WIZARDS WORKSHOP

TEKTRONIX INTERNAL USE ONLY

TABLE OF CONTENTS

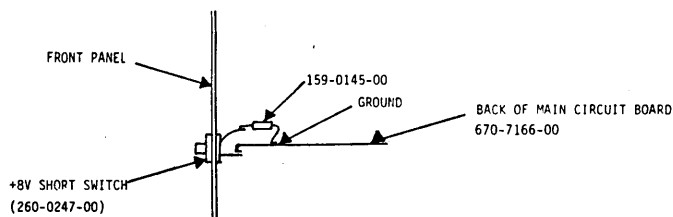
To prevent possible board damage when testing a defective +8V supply, a 15A fuse, P/N 159-0145-00, should be installed between the +8V short switch and ground on the back of the main circuit board. (See Figure 1). For future reference, make this correction on Schematic 1 of your manual.

492/P JUMPERS ON PRESELECTOR DRIVER BOARD P/N 670-5552-03

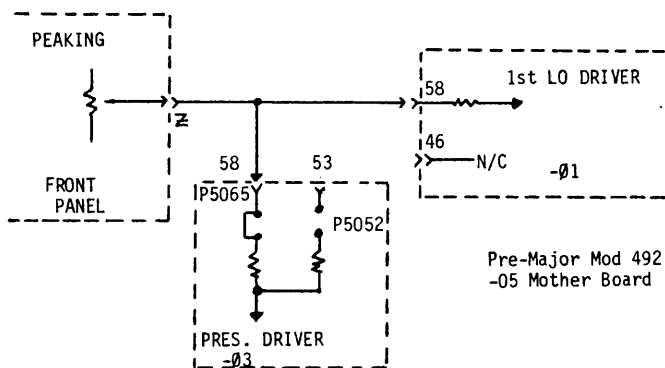
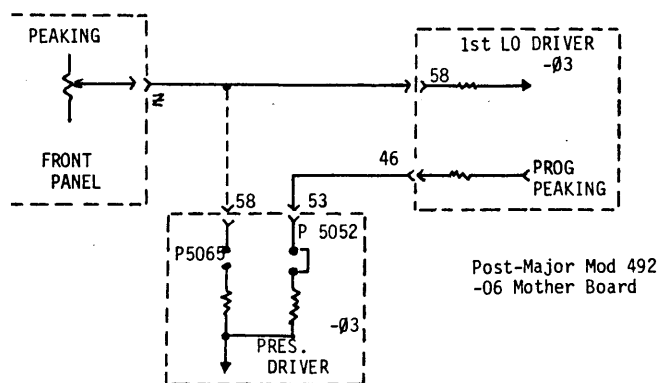
1. In post major mod 492's (B03XXXX and above) and all 492/P's, P5052 should have a jumper on it and P5065 should be open. This connects the Peaking control to the Preselector Driver via the first LO Driver programmable peaking output on Pin 46.
2. In pre major mod 492's (below B03XXXX) with a first LO Driver, 670-5550-01 or -00, P5065 should have a jumper on it and P5052 should be open. This connects the Peaking control to the Preselector Driver via Pin 58 on the Mother Board connector. Pin 46 on the first LO Driver has no connection on the -01 board.

Presently in 492's with -06 Mother Boards, the Peaking control will work

with the jumper on either plug since there is an extra run in the -06 Mother Board between Pins 58 on the LO Driver, and Preselector Driver (see accompanying schematic). Connect the jumpers as in #1 above.

If the jumpers are incorrect on a 492/P, the Peaking control will be useable, but the Programmable Peaking will not work.

7104, 7854 LOW LINE, HIGH LOAD, SCHEMATIC CORRECTION

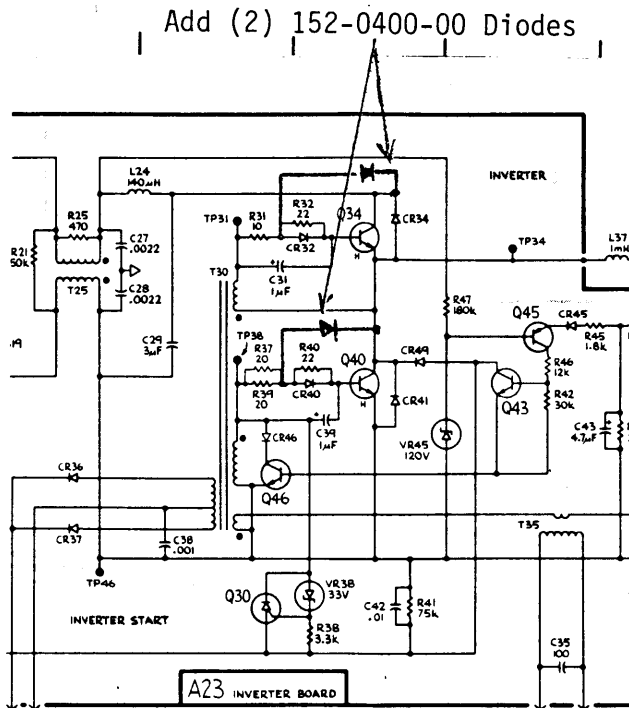
In the above mentioned issue the schematic shows CR33 connected to R47. It should be connected to the collector of Q34 as shown below.
